SEWAGE DISPOSAL SYSTEM

DEPARTMENT OF HEALTH AND MENTAL HYGIENE

SUBDIVISION Evergreen Valley Estates LOT 33, Sect. 6 ROAD 3135 Evergreen Way

REPAIR - PURPOSE - SEPTIC SYSTEM HAS FAILED.

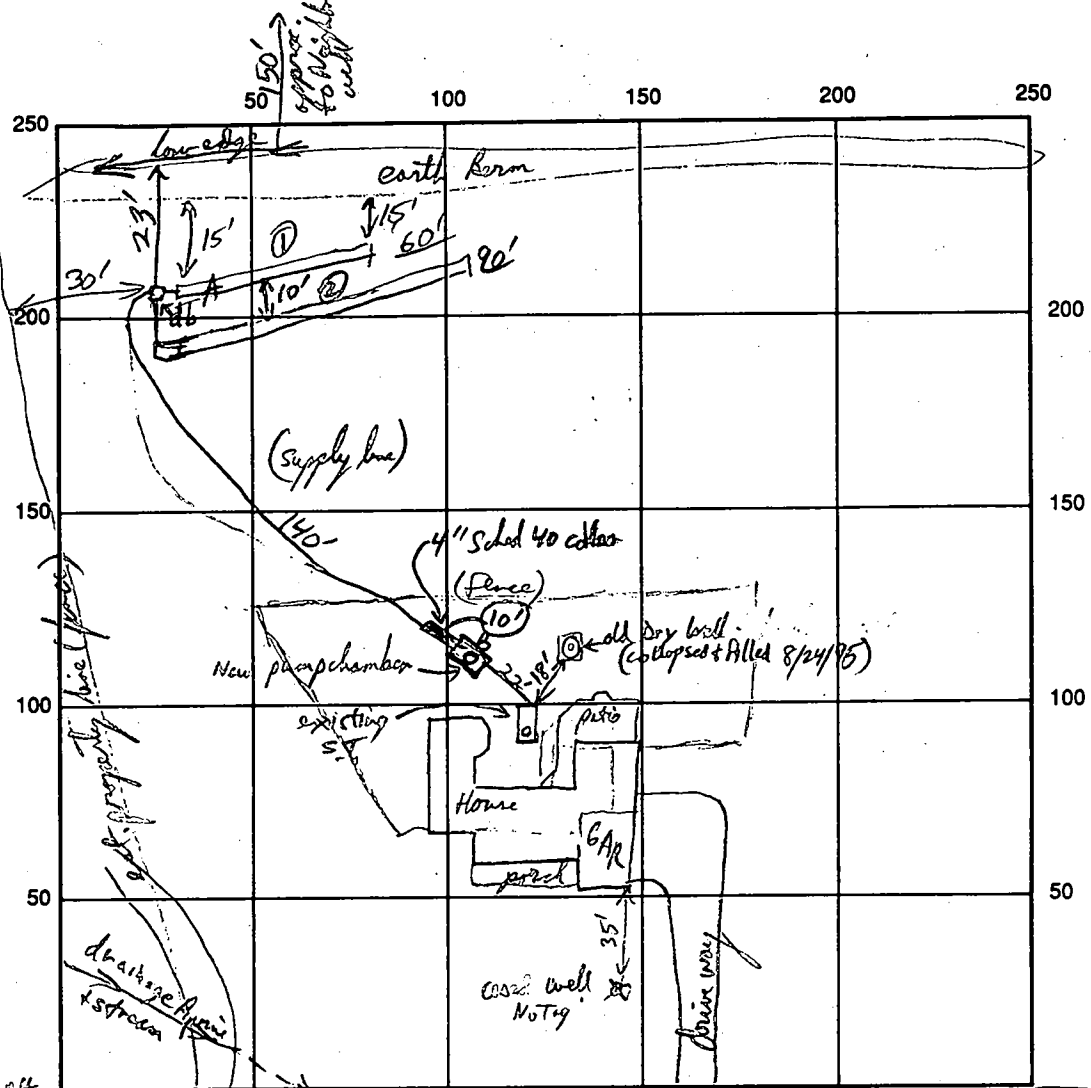
Call for inspection when ground is opened so sanitarian can recommend repair.
OK to dis connect old Dry well. Need a pump & pump chamber to pump to trench on high side
Install two 60ft long trenches, 2ft wide, 6ft deep. of lot.
- Inlet depth 2 feet. OK
- Maximum bottom depth 8 feet. OK

REMARKS: Excavation for pump chamber has very dark brown coarse sand, brown and water seepage at 9-10 ft.
Use a Top Seamed pump chamber, OK to cover trenches when finish gravel filling. Need to
call for pump test and supply line check out. 8/23/95 RPP 2" flexible supply line OK to cover,
Dry well being collapsed & filled, OK RPP 8/24/95 5/9/97 PUMP + CONTROL OPERATION (ALARM)
CHECK - OK. RPP FINAL WHEN PAID (epoch NOT IN USE 5-9-97)

LOCATION SURVEY
 LOT 33 SEC. 6
 EVERGREEN VALLEY ESTATES
 THIRD ELECTION DISTRICT
 HOWARD COUNTY, MARYLAND
 SCALE 1"=50' JULY 6, 1972

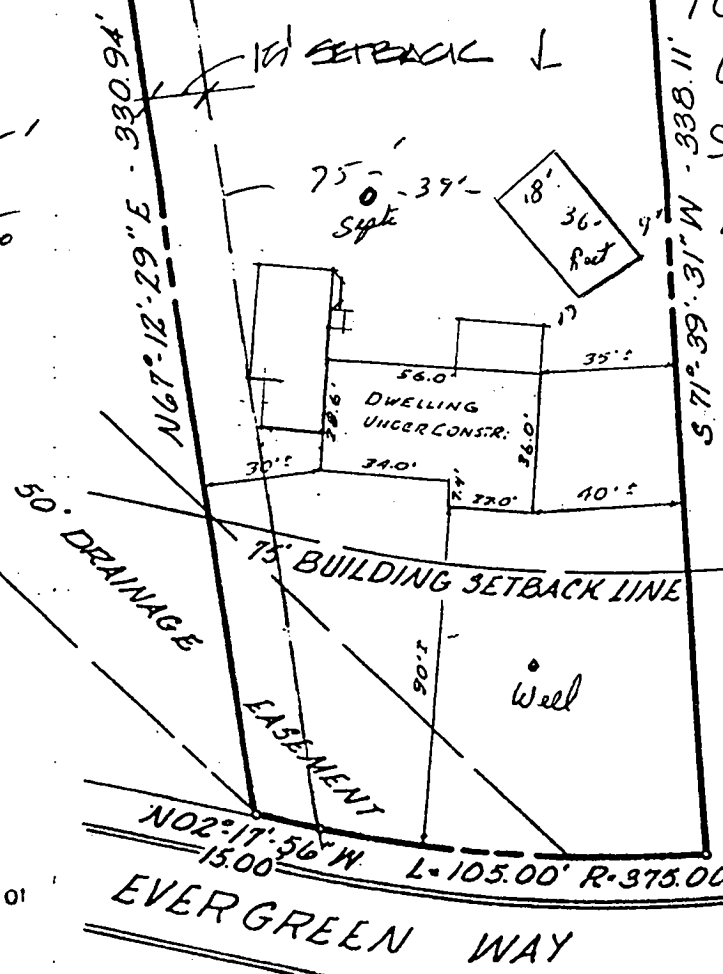
POOL
OK TO
SIGN
MR
